ENERGY NORTHWEST

September 5, 2000
GO2-00-154

Subject: **WNP-2, OPERATING LICENSE NPF-21
REQUEST FOR AMENDMENT
TECHNICAL SPECIFICATIONS 3.3.5.1, 3.3.6.1 and 3.3.6.2**

Description of Proposed Changes

FIGURE 1
PRIMARY CONTAINMENT
INBOARD ISOLATION LOGIC
(PARTIAL)
[TYP. FOR OUTBOARD
SHOWN IN ()]
REF. FSAR
FIGURE 7.3-8.1

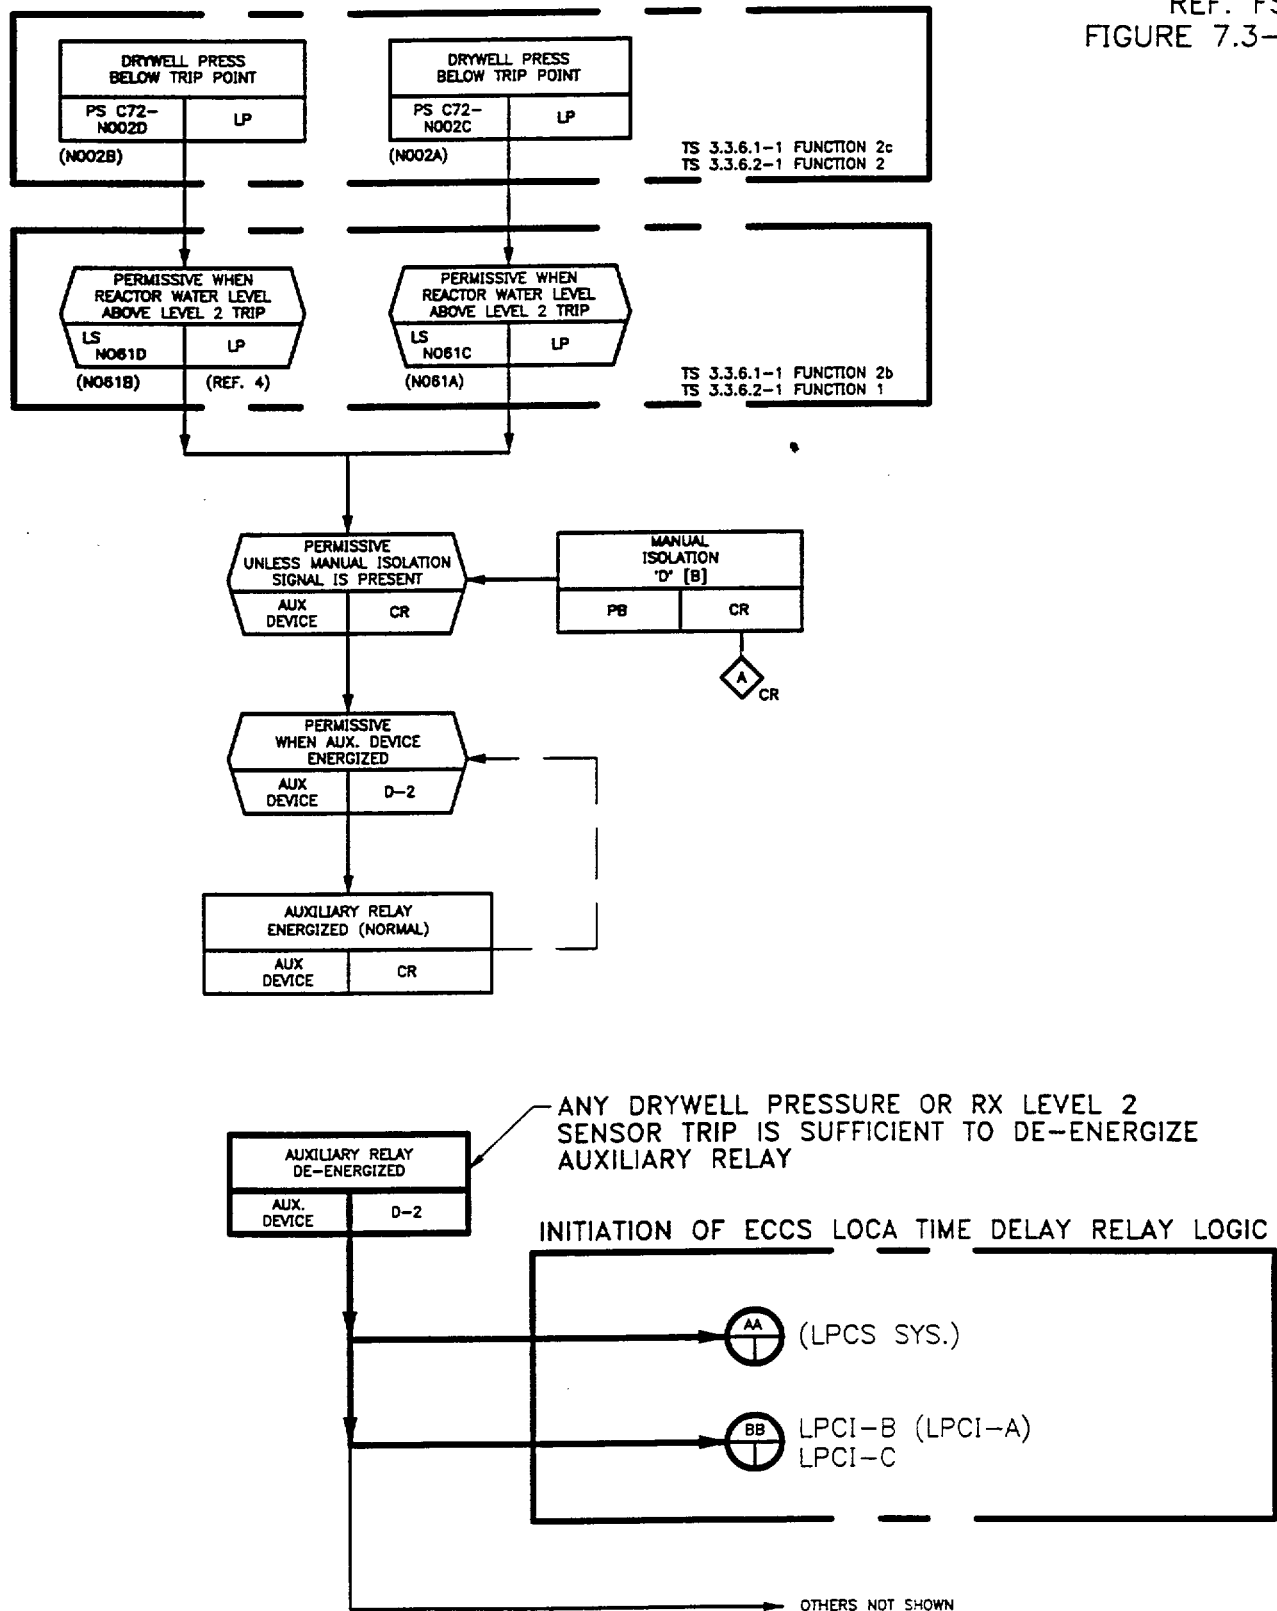
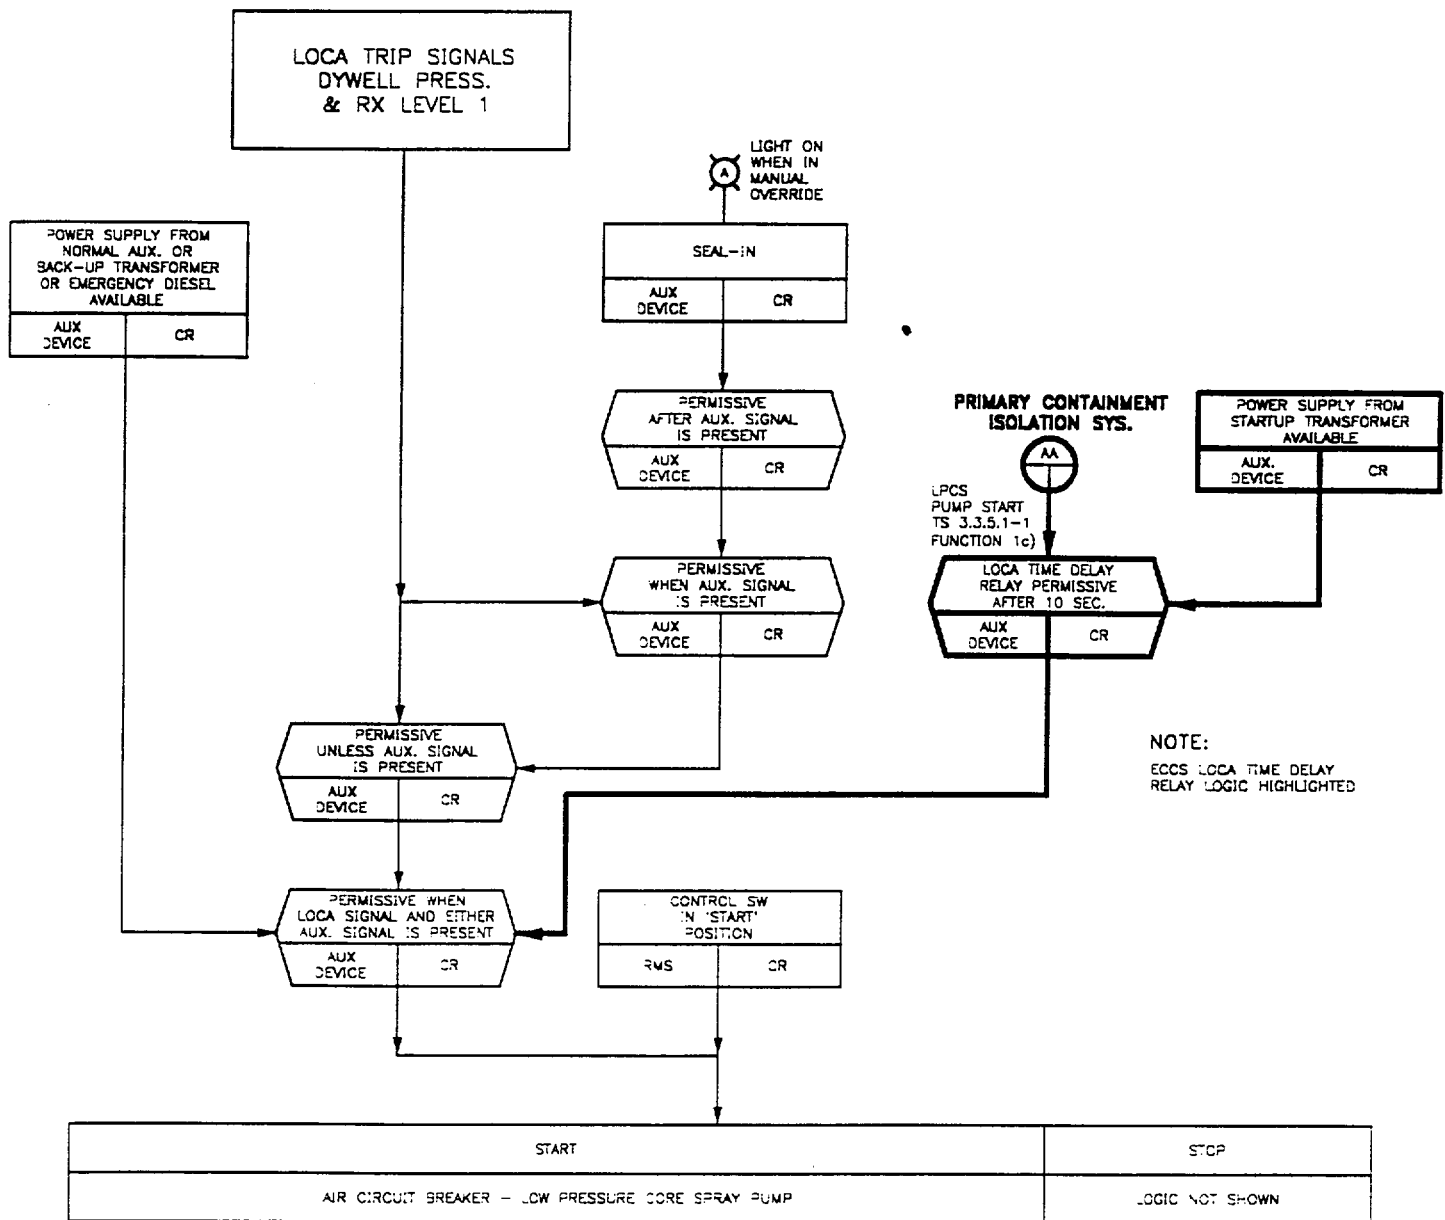
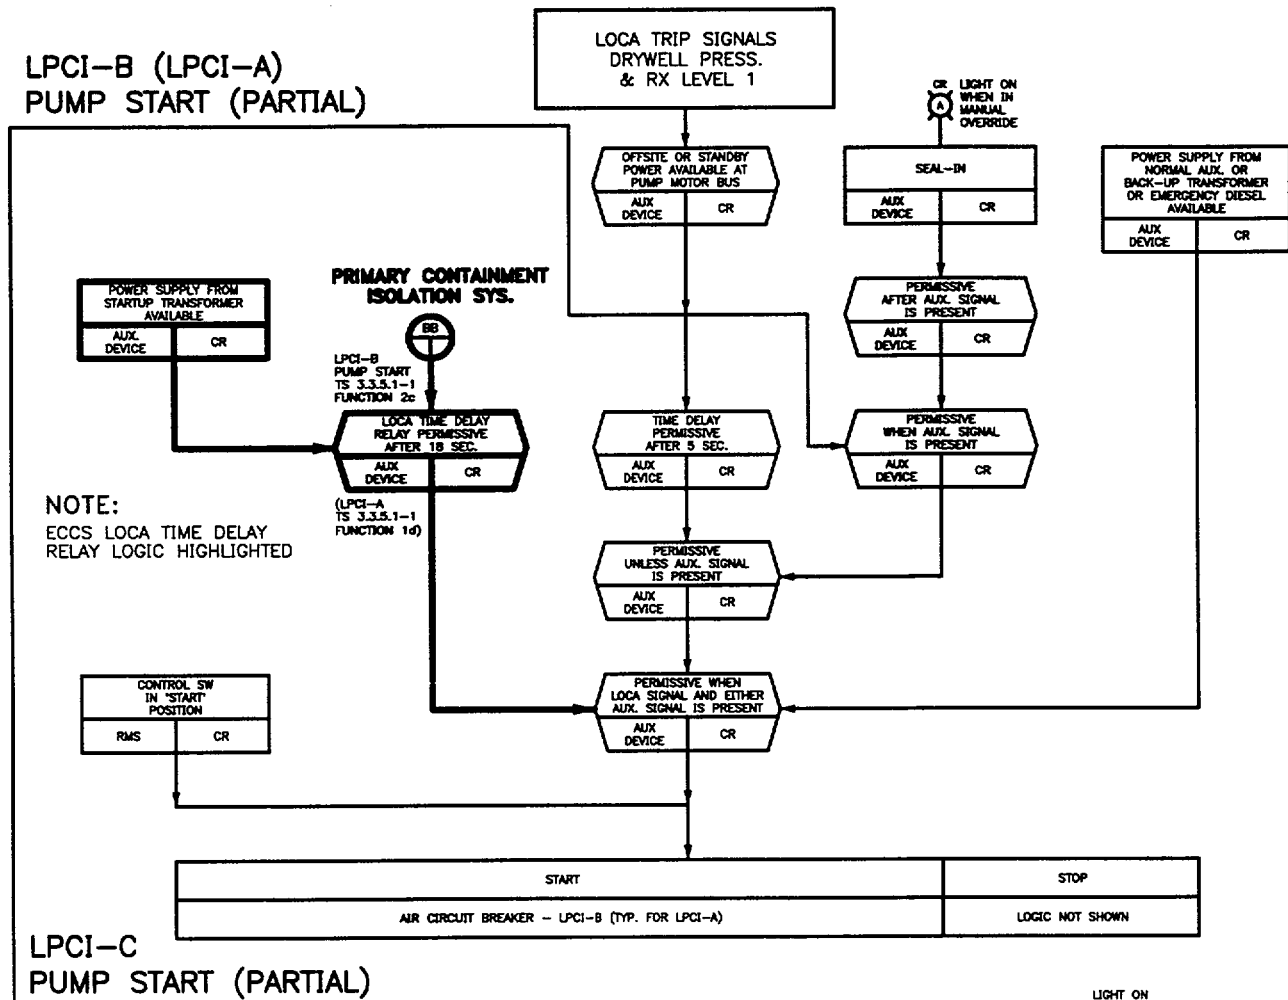
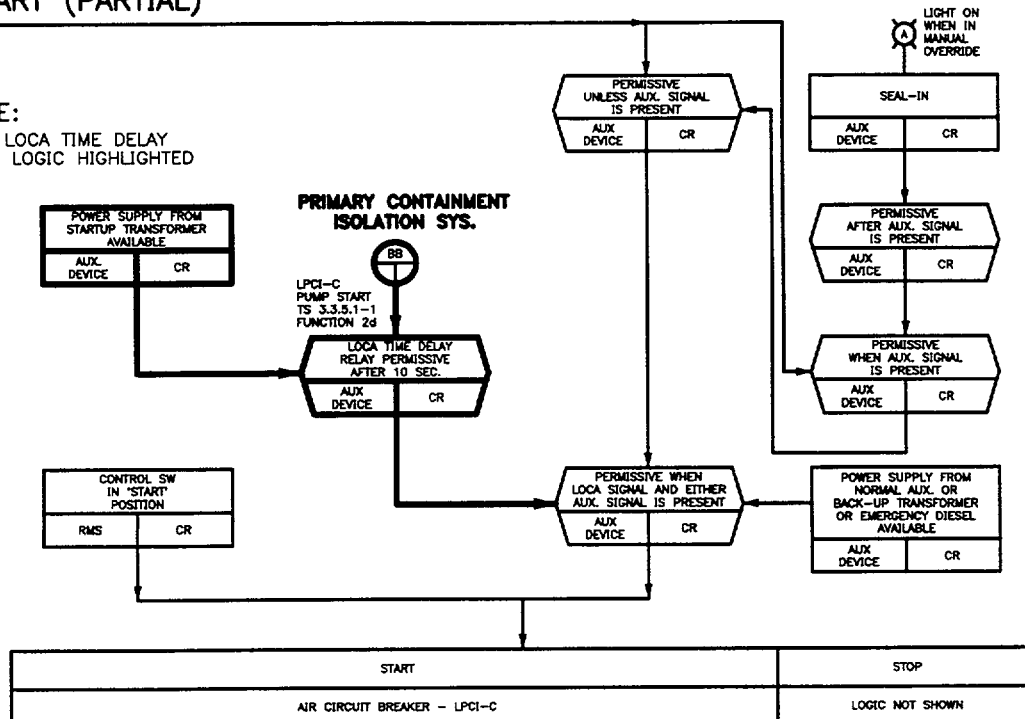
Pump-start TDR channels are included in each of the Division 1 and 2 low pressure ECCS pump-start logic trains. Each of the four low pressure ECCS pump-start designs contain a TDR relay channel initiated by a Drywell Pressure-High or a Reactor Vessel Water-Low Low, Level-2 sensor contact in series, together with other logic associated with electrical system relay and circuit breaker position. The WNP-2 design is such that actuation of any one of the sensors results in providing an actuation signal to the TDR channels for both low-pressure ECCS pumps in the same electrical division (See Figures 1-3).

In the event that one of the sensors was spuriously actuated, or was placed in the trip condition as required by any of the affected Technical Specifications (in the case of an inoperable instrument), both LOCA TDR channels in the division would receive an actuation signal. When power is aligned to the 230 kV offsite power source, the time delay relays will start and time-out, setting up the logic for simultaneous starts upon receipt of a LOCA signal (See Figures 1-3). Since the actual start of the low pressure pumps is dependent on LOCA signals that originate in other branches of the WNP-2 instrumentation systems (See Figures 2-3),

neither low pressure ECCS pump would start immediately. However, if a Loss of Coolant Accident (LOCA) Drywell Pressure-High signal was received after the sequenced TDRs had both timed-out, both low pressure ECCS pumps in that electrical division would start at approximately the same time as the HPCS pump. Likewise, if a loss of coolant accident caused a rapid decrease in reactor vessel water level, the level-1 LOCA signal could be initiated closely following the level-2 signal causing a similar multiple pump start condition. This would result in a significant voltage transient on the 230 kV offsite power transformer as discussed above. Therefore, the note is proposed to be added identifying the 230 kV offsite power source as an associated supported feature.

The primary and secondary containment isolation channels specified in Table 3.3.6.1-1 (Functions 2b and 2c) and in Table 3.3.6.2-1 (Functions 1 and 2) initiate the LOCA TDR specified in Table 3.3.5.1-1 (Functions 1c, 1d, 2c, and 2d). Since these Drywell Pressure and Reactor Level 2 signals are used in several functions governed by multiple Technical Specifications, we are proposing to add notes to these Technical Specifications to identify the branching to the other requirements. The note to the, "Required Channels Per Trip System," column for Table 3.3.6.1-1 Functions 2c and 2d is, "(e) Also required to initiate the associated LOCA Time Delay Relay Function pursuant to LCO 3.3.5.1." The note for 3.3.6.2-1 Functions 1 and 2 is identical, except it is labeled as Note (c). These notes will direct the operators to LCO 3.3.5.1 and a more restrictive Action.

This proposed change is being initiated to make explicit what is currently required for LCO 3.3.5.1 Functions 1c, 1d, 2c and 2d instrument channel and 230 kV offsite source Operability. This change is being requested so that operators may more easily determine the most restrictive Action and Completion Times for performing routine plant operations such as surveillance testing.
